# Commonwealth Utilities Corporation

CUC-RFP-25-021

Independent Power Producer-Solar Photovoltaic with Battery Energy Storage System (BESS)  
for all Islands, CNMI

### **Question (RFI/C) No. 017: AP ENERGY LLC**

## TINIAN SINGLE LINE DIAGRAM

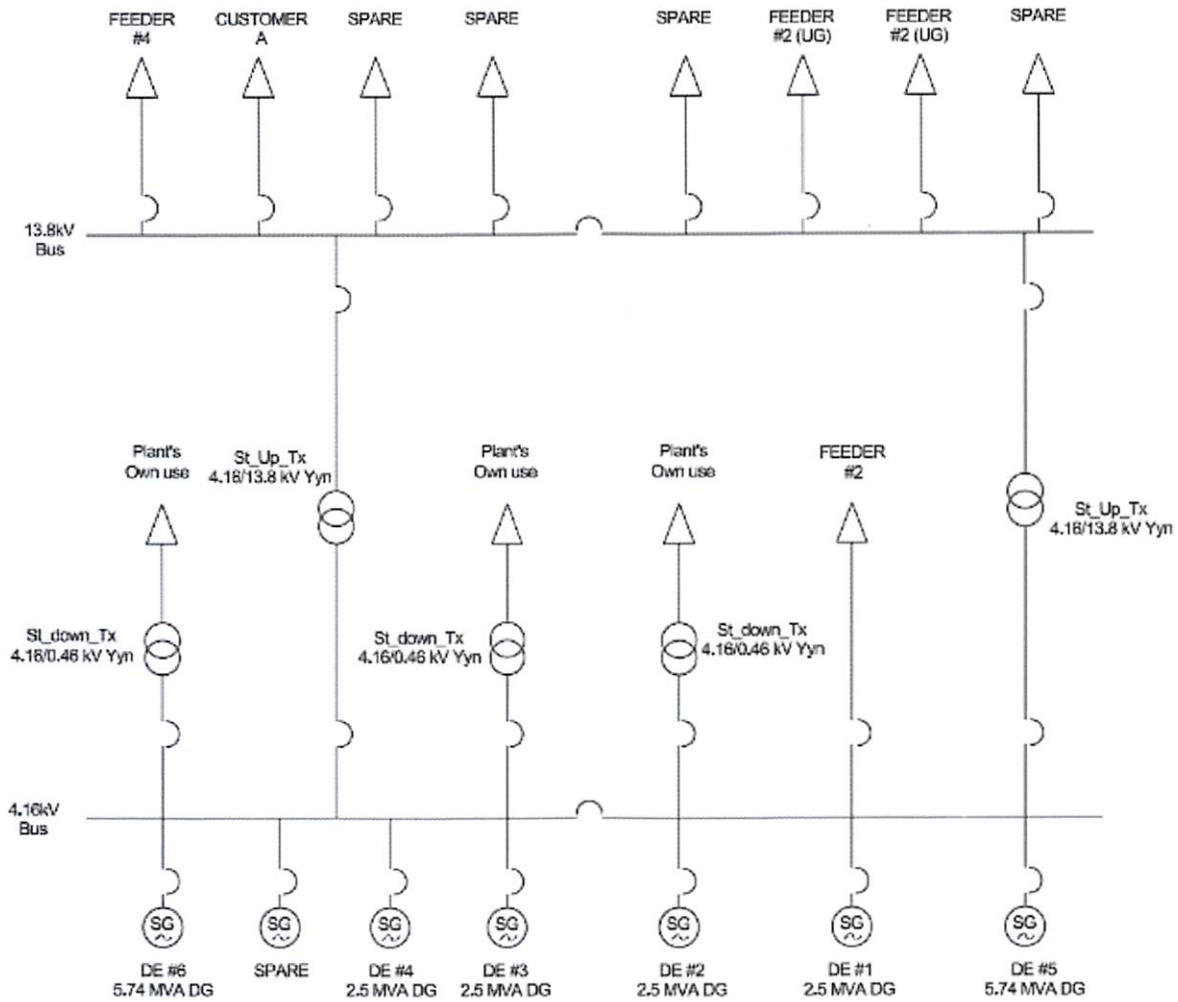
15. Could we get a single-line diagram for the transmission lines for Saipan, Tinian, and Rota?

**CUC RESPONSE:** The single-line diagrams for Saipan, Tinian and Rota are attached at the end of this document.
